**Overview:** The FTI-STP1 harness may require modification for use in **automatic transmission (AT)** applications, some of the product was able to be modified before release, but a small quantity was released before being able to be modified internally.

# FTI-STP1: Vehicle Coverage and Preparation Notes

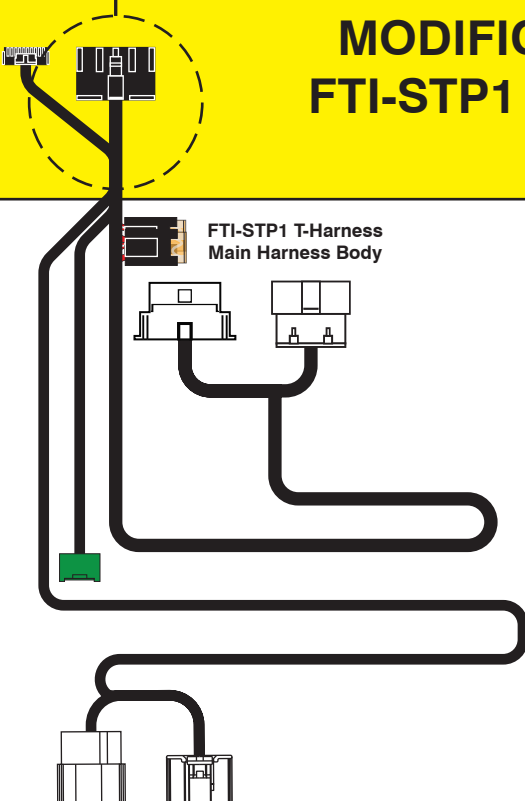
**Issue:** The FTI-STP1 T-harness has been designed to be compatible with AT (automatic transmission) & MT (manual transmission) applications, but due to a production oversight, the selection mechanism was defaulted to MT mode.

Using a harness configured for an MT application, in an AT equipped vehicle, could result in vehicle module damage, it is advised that the harness be returned to AT mode before installation in vehicles equipped with an automatic transmission.

**Correction:** Locate the **red/black (+ Clutch)** wire provided in the CN1 connector of the main harness assembly. Cut the **red/black** wire, either flush to the CN1 connector, or leaving enough wire exposed so that you can insulate and secure the ends of the wire that remain after cutting. Insulate each of the remaining ends of the **red/black** wire and secure to prevent any possibility of a short circuit.

If the red/black wire already been disconnected, no further modification is required for AT equipped vehicles.

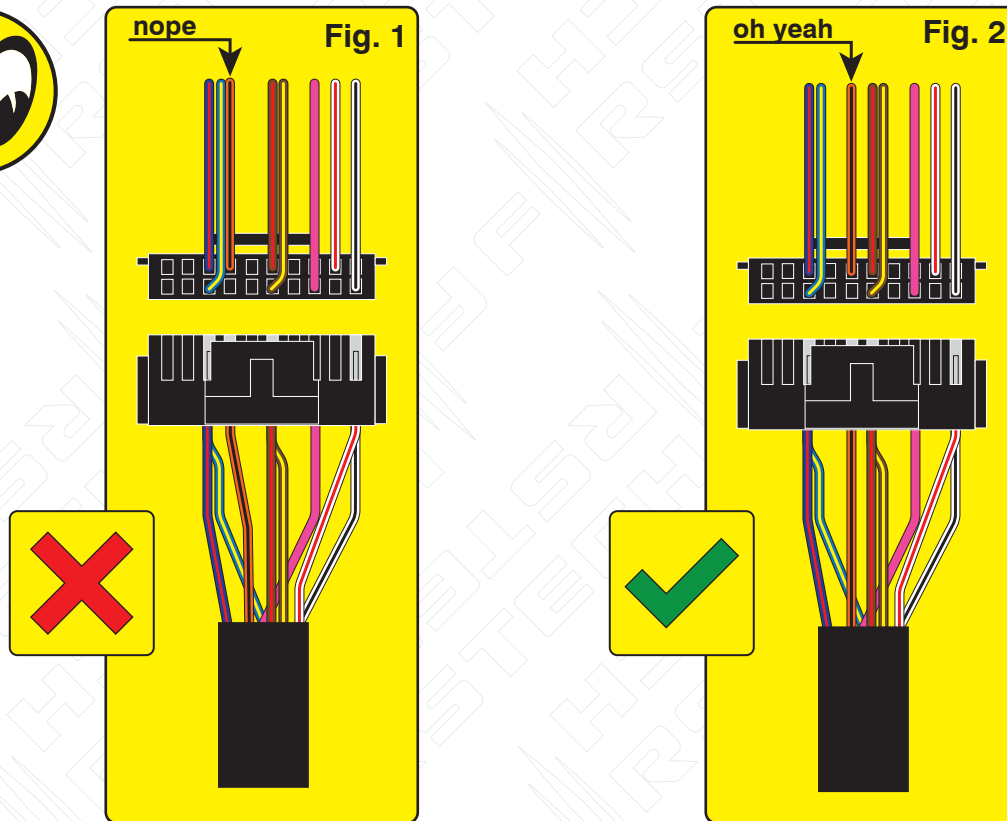
**Overview:** Production error; immobilizer wire (orange/black) in pin position #4 instead of pin position #5. Although an effort to correct the issue was made, some quantity of harnesses did get shipped before the issue was spotted. We are advising to inspect the harness BLADE connector before attempting to install the harness and program the module.

**Issue:** Module fails to program to vehicle, will not allow the vehicle to be remote started.

**Correction:** Step 1.) Locate the orange/black wire and confirm whether it is positioned as illustrated in Fig. 1 or Fig. 2. If the wire is as illustrated in Fig.1, proceed with Step 2 through 5 and complete the repair procedure outlined, if the wire is as illustrated in Fig. 2, correction is not necessary, proceed with harness installation and module programming.

**Step 2.)** Using a pick, lightly depress the catch that secures the terminal in the housing then remove the wire and terminal from the housing.

**Step 3.)** Using a fine tip razor or utility knife, insert the blade beneath the terminal catch and raise it slightly, so that it can be reused to secure the terminal when reinserted into the BLADE connector housing.

**Step 4.)** Refer to Fig. 2 for correct position of the orange/black wire (next to brown/red) then reinsert the terminal, pressing lightly until the catch 'snaps' into place, securing the terminal in the connector housing.

**Step 5.)** The repair is complete, proceed with installation and programming.
